EXISTING & PROPOSED AREA
SANITARY SEWER

McAdams Park

PAID BY PARK COMMISSIONERS
WICHITA, KANSAS

PLAN SCALE: 1"=10'-0" Sht #2

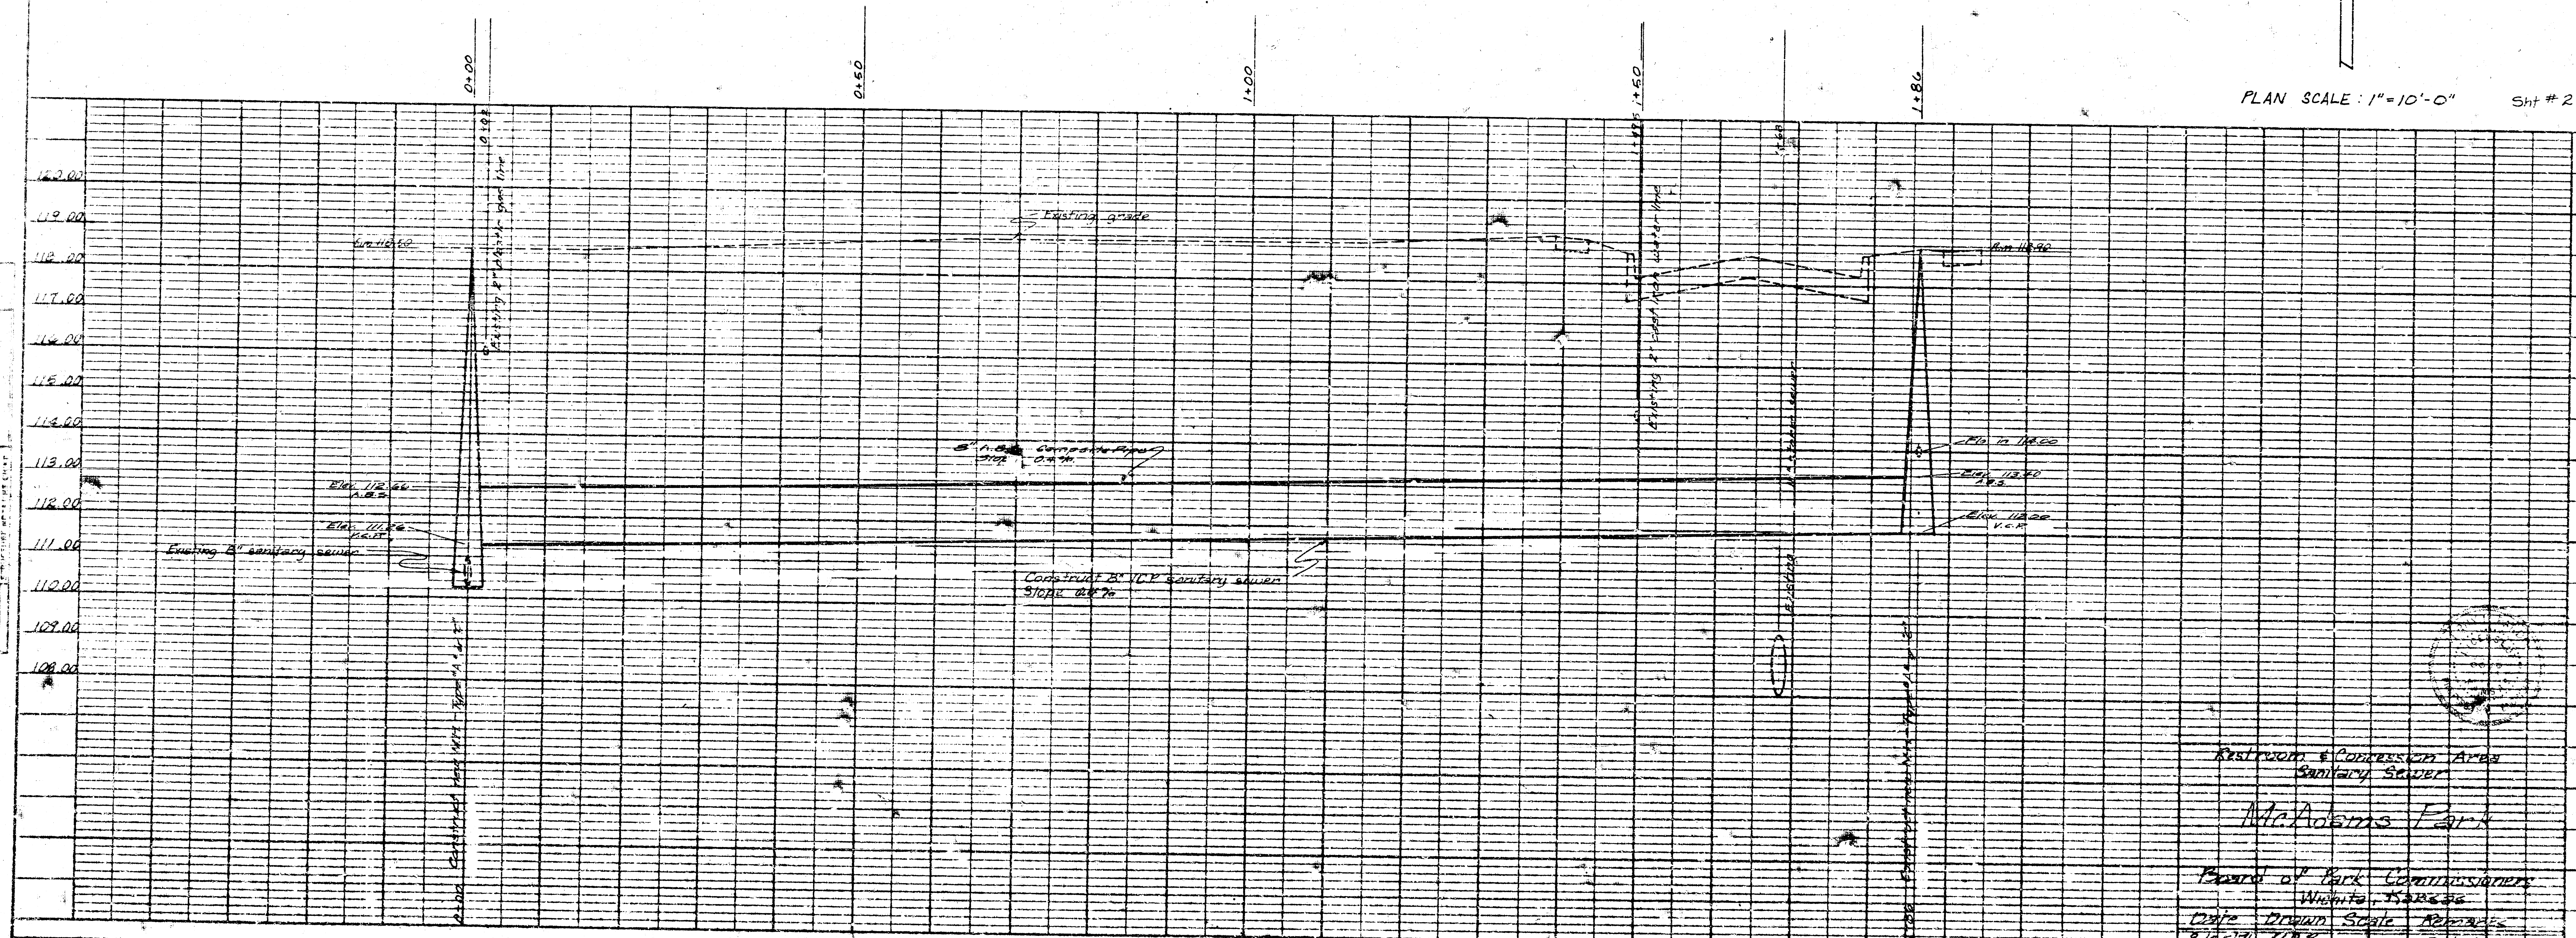
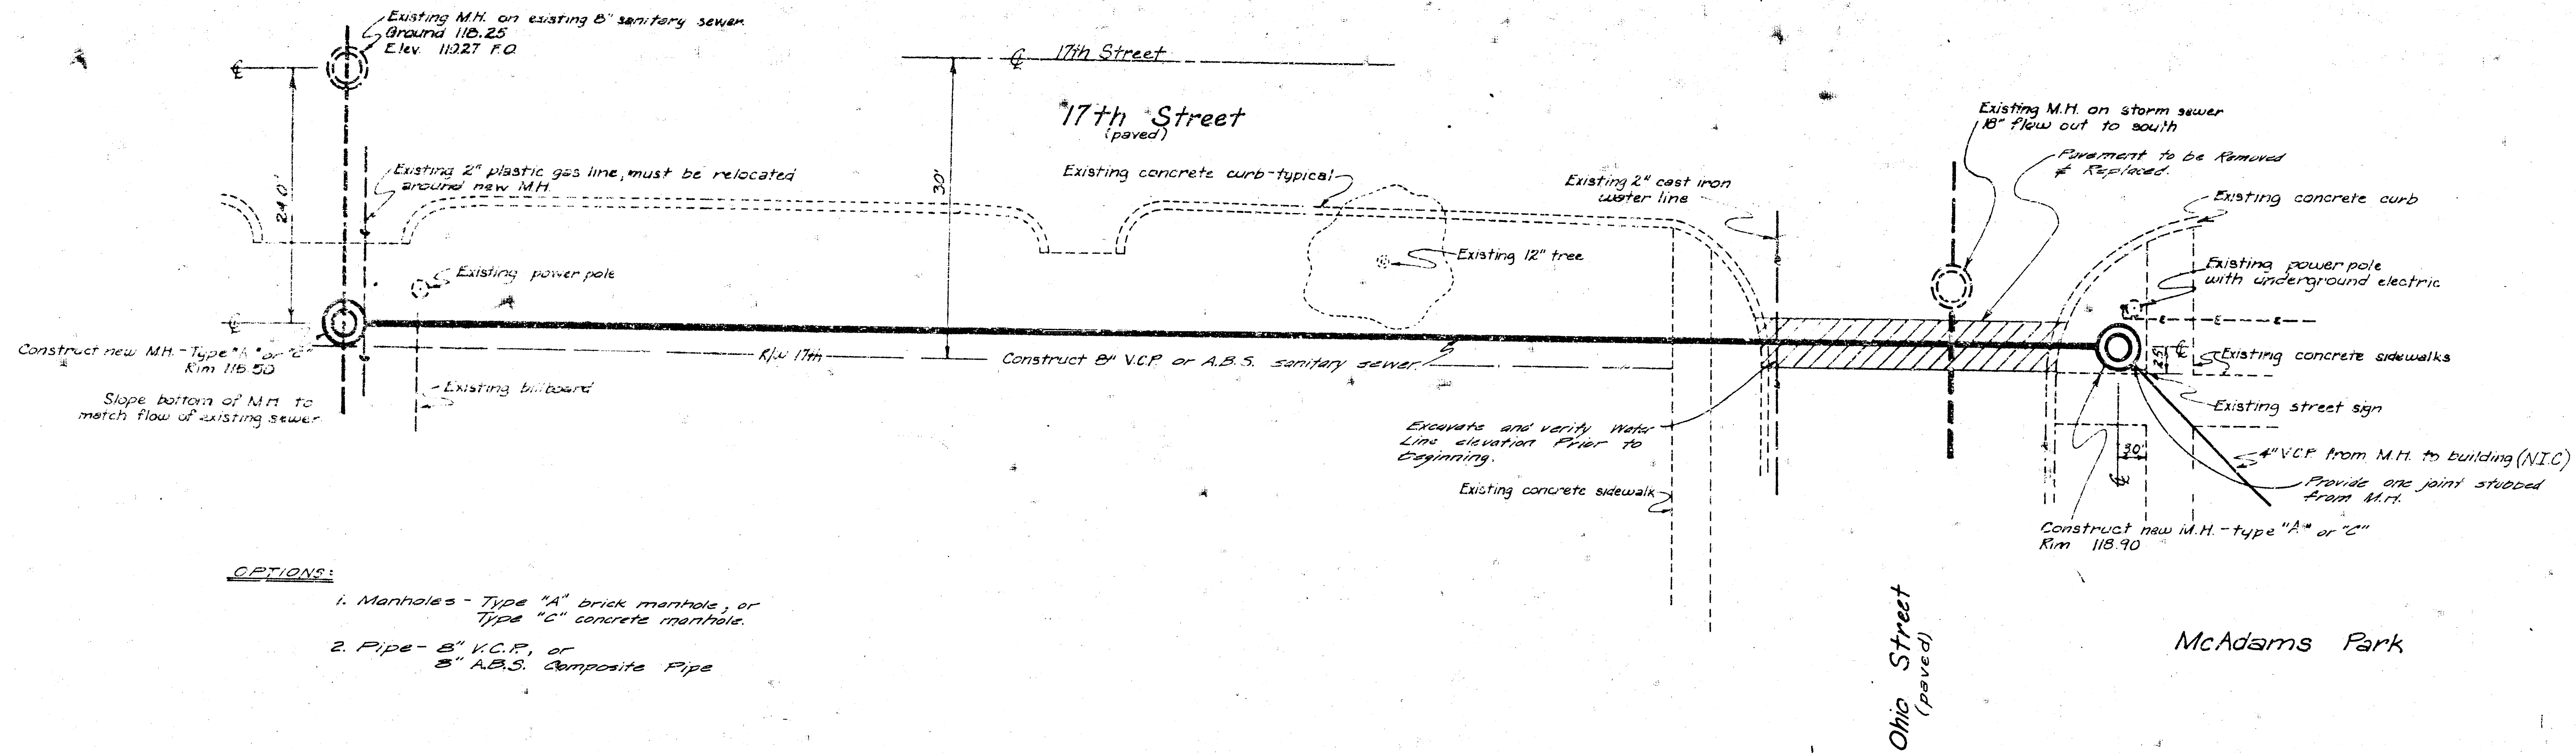
OPTIONS:

1. Manholes - Type "A" brick manhole, or Type "C" concrete manhole.
2. Pipe - 8" V.C.P. or 8" A.B.S. Composite Pipe

APPROVED AS NOTED
By CITY ENGINEER OF WICHITA
Sanitary Sewers D.E.S.
Storm Sewers _____
Driveway Approaches _____
